**Safety Evaluation Report for the
Hanford Unirradiated Fuel Package
Safety Analysis Report for Packaging
HNF-28554, Revision 2, August 2008**

August 28, 2008

Figure 5.3-1 Applicant's DFA and IDENT-69G Models – Cross Section View

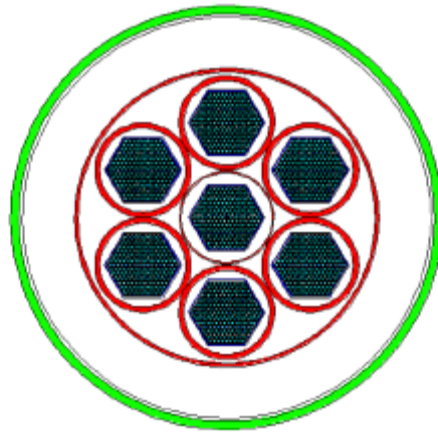
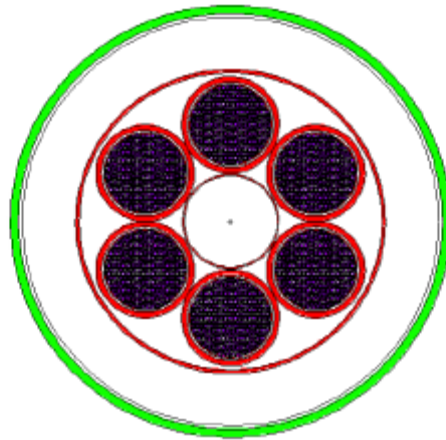
The Applicant used MCNP^[5-8] to perform detailed 3-D shielding calculations. The shielding models are based upon the configurations developed for the criticality analysis presented in Chapter 6 of the SARP. Figure 5.3-1 of this SER shows the cross sections of the DFA and IDENT-69G models. The source in each model is evenly distributed throughout the active length of the fuel rods. No water is modeled in the system as it would moderate the neutron spectrum and reduce the neutron dose rate. Because the regulatory drop tests and the structural analyses given in Chapter 2 demonstrated that possible damage to the HUFPP was minimal, the Applicant used only NCT models in the calculations.

Figure 5.3-2 Applicant's Tally Locations - DFA Model

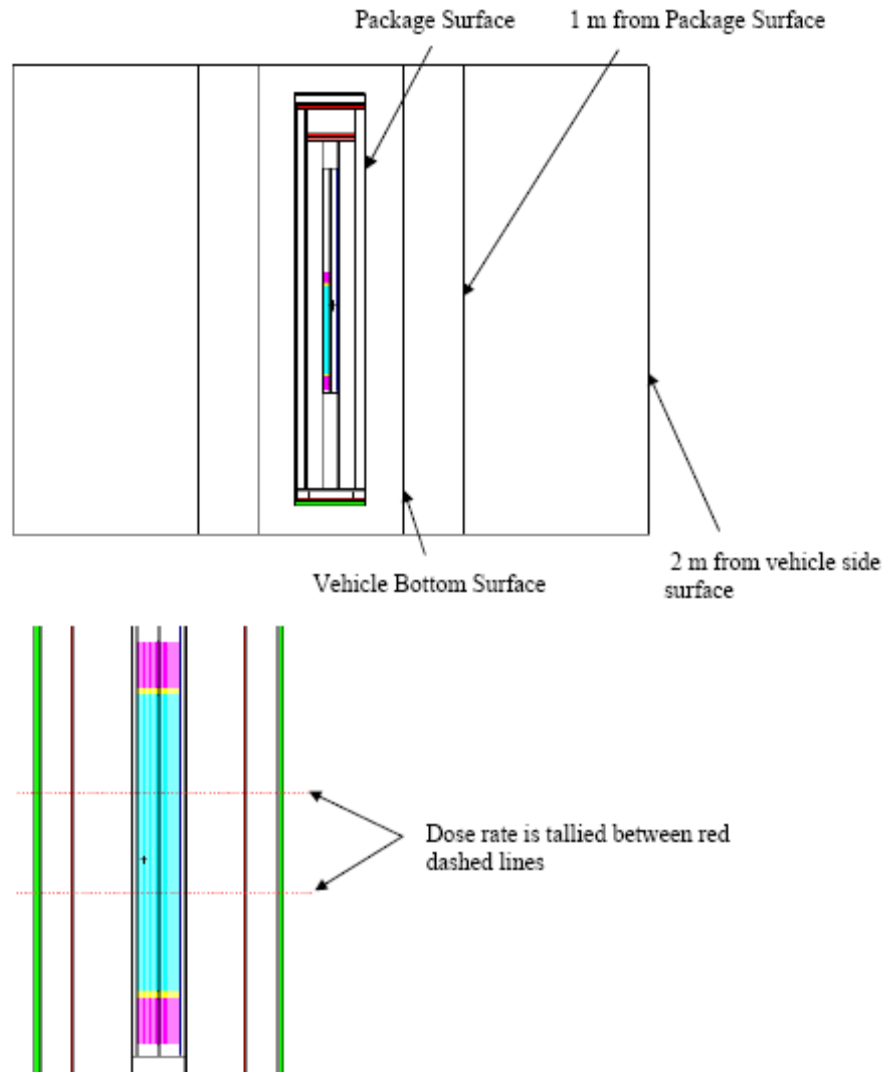
The SARP models contained all relevant dose rate locations for both NCT and HAC. The Applicant's dose rate locations conservatively represent the dose rate locations for a HUFPP on a transport vehicle. Circumferential surface dose rate (F2) tallies are specified for the package surface, the transport vehicle surface, and 2 m from the transport vehicle surface. The tallies are centered on the axial center of the fuel in the package (fuel length = 36 inches) and are modeled as 12 inches wide (See SER Figure 5.3-2).
